BUILDING CODE ACTION COMMITTEE MEETING EXISTING BUILDINGS WORK GROUP

APRIL 11-12, 2019 MEETING

BCAC Code Change Proposals and Related Proposals

Existing Building committee – List of proposals

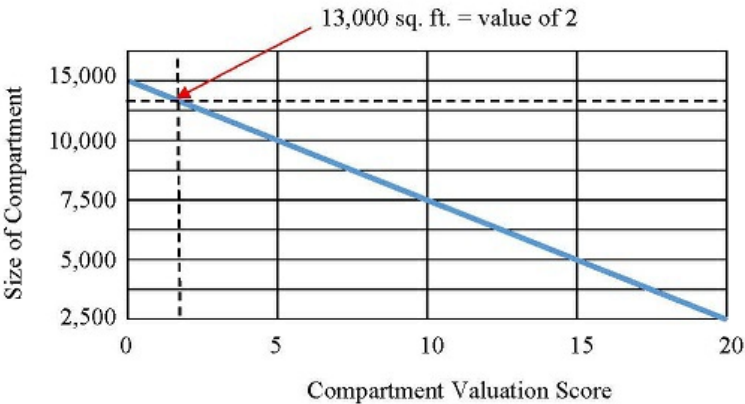
Reason: This proposal is designed to correct an inconsistency in Table 1301.6.3. Currently, there is a hole in the size values for compartment size. There is no recognition of a fire compartment that is between 10,000 and 15,000 square feet.

- Category a applies to 15,000 sq. ft. or larger
- Category b applies to 10,000 sq. ft. or less

So what value is applied when the fire compartment is 12,000 square feet. It is not listed on the table and there is no guidance as to the value associated to this size. Obviously, it is better than 15,000 square feet, but is it the same value as 10,000 square feet.

Therefore, this proposal makes two revisions:

Moving the criteria out of the table header is an editorial change. But it is consistent with the format used in all the other tables in Chapter 13. It also allows for easier application and use of the table.
